Yellow Brook Property Co.
91 Rumson Road
Block 124, Lot 31

CONSTRUCTION OF A MULTIFAMILY RESIDENTIAL HOUSING DEVELOPMENT

RESIDENT PUBLIC COMMENT TO BE READ INTO RECORD

Subject: Proposed Development - Lot 31 Block 124

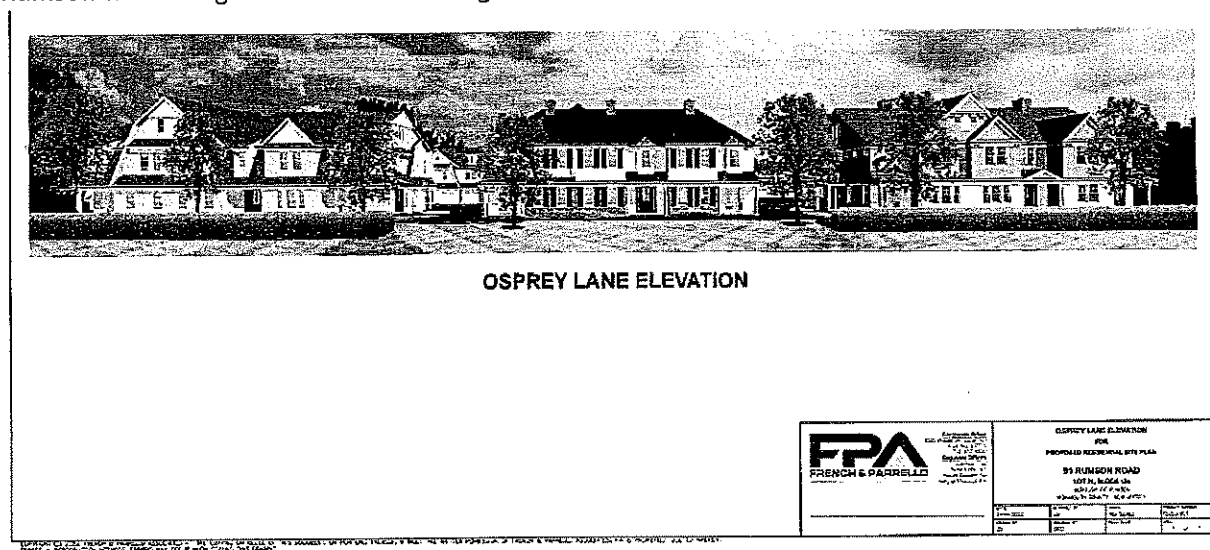
Exhibit C of the Settlement Agreement is titled "Concept Site Plan and Elevations² for Rumson Road Development." The Osprey Lane Elevation rendering included in Exhibit C to the Settlement Agreement seen below can be found on page 46 of 82 of the Settlement Agreement.

The Osprey Lane Elevation rendering (below) clearly does not contemplate the significant elevation increase included in Yellow Brook's proposed site plan for the 91 Rumson Road property. The significant increase to elevations proposed by Yellow Brook for the property were not agreed to by the Borough of Rumson when it signed the Settlement Agreement as seen below.

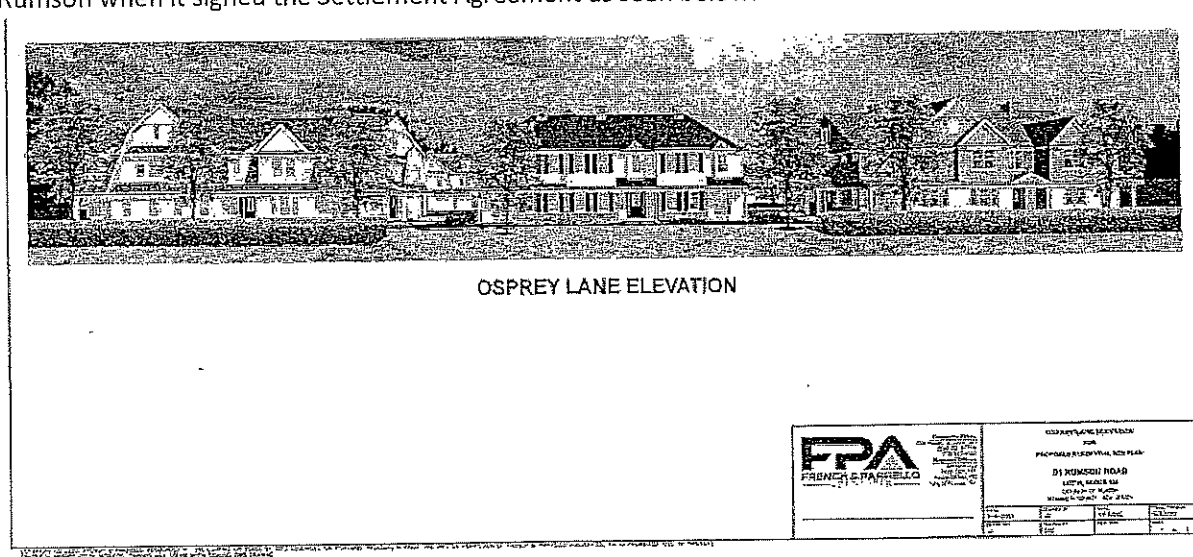
Exhibit C of the Settlement Agreement is titled "Concept Site Plan and Elevations² for Rumson Road Development." The Osprey Lane Elevation rendering included in Exhibit C to the Settlement Agreement seen below can be found on page 46 of 82 of the Settlement Agreement.

The Osprey Lane Elevation rendering (below) clearly does not contemplate the significant elevation increase included in Yellow Brook's proposed site plan for the 91 Rumson Road property. The significant increase to elevations proposed by Yellow Brook for the property were not agreed to by the Borough of Rumson when it signed the Settlement Agreement as seen below.

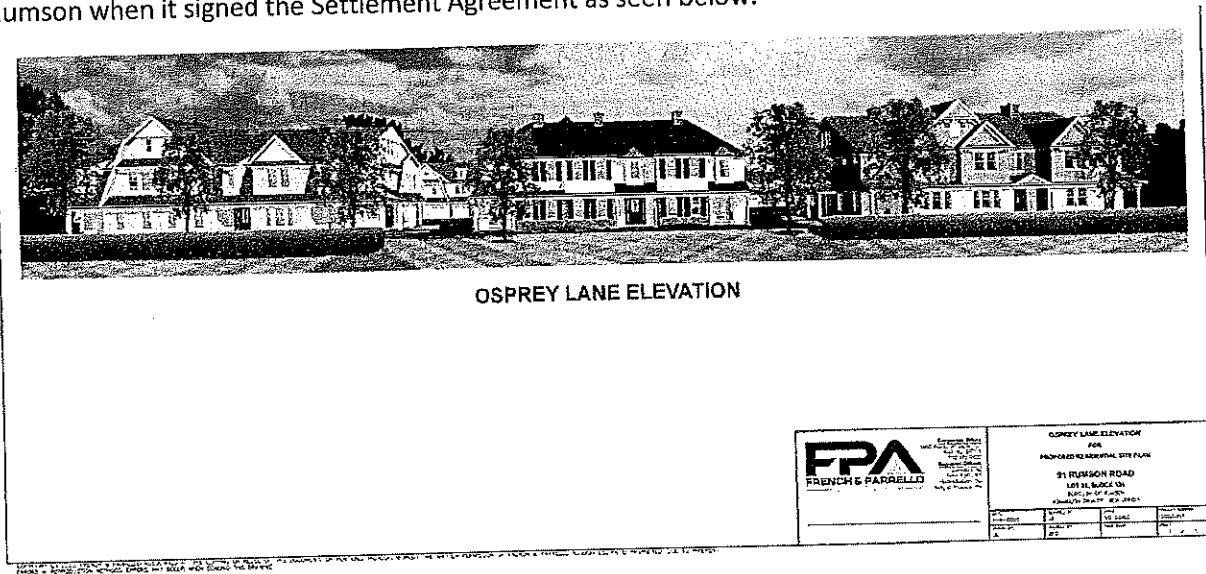
Exhibit C of the Settlement Agreement is titled "Concept Site Plan and **Elevations**² for Rumson Road Development." The Osprey Lane Elevation rendering included in Exhibit C to the Settlement Agreement seen below can be found on page 46 of 82 of the Settlement Agreement.

The Osprey Lane Elevation rendering (below) clearly does not contemplate the significant elevation increase included in Yellow Brook's proposed site plan for the 91 Rumson Road property. The significant increase to elevations proposed by Yellow Brook for the property were not agreed to by the Borough of Rumson when it signed the Settlement Agreement as seen below.

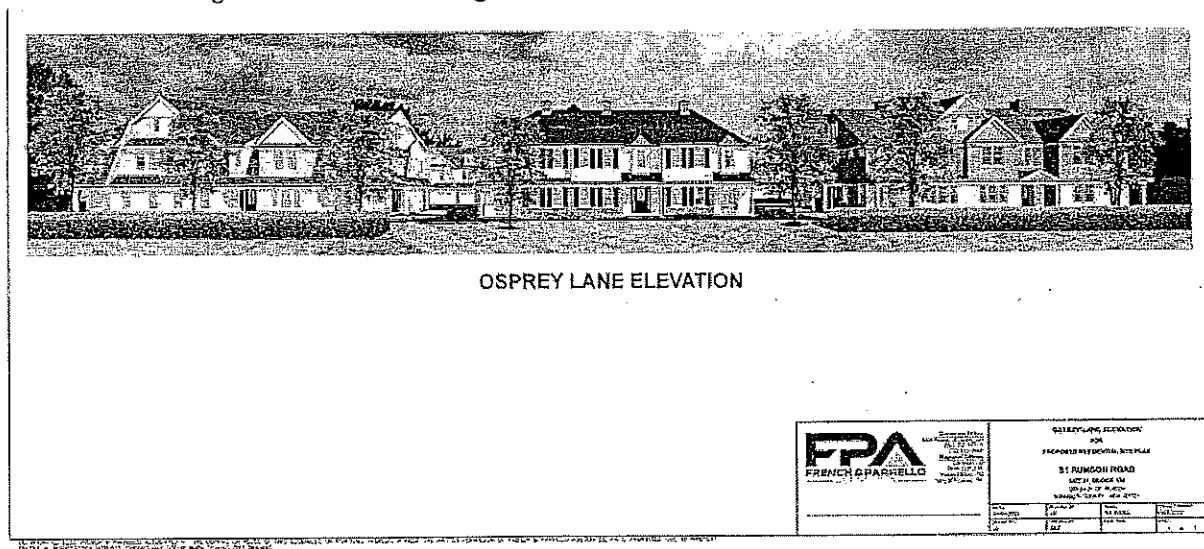
Exhibit C of the Settlement Agreement is titled "Concept Site Plan and Elevations² for Rumson Road Development." The Osprey Lane Elevation rendering included in Exhibit C to the Settlement Agreement seen below can be found on page 46 of 82 of the Settlement Agreement.

The Osprey Lane Elevation rendering (below) clearly does not contemplate the significant elevation increase included in Yellow Brook's proposed site plan for the 91 Rumson Road property. The significant increase to elevations proposed by Yellow Brook for the property were not agreed to by the Borough of Rumson when it signed the Settlement Agreement as seen below.
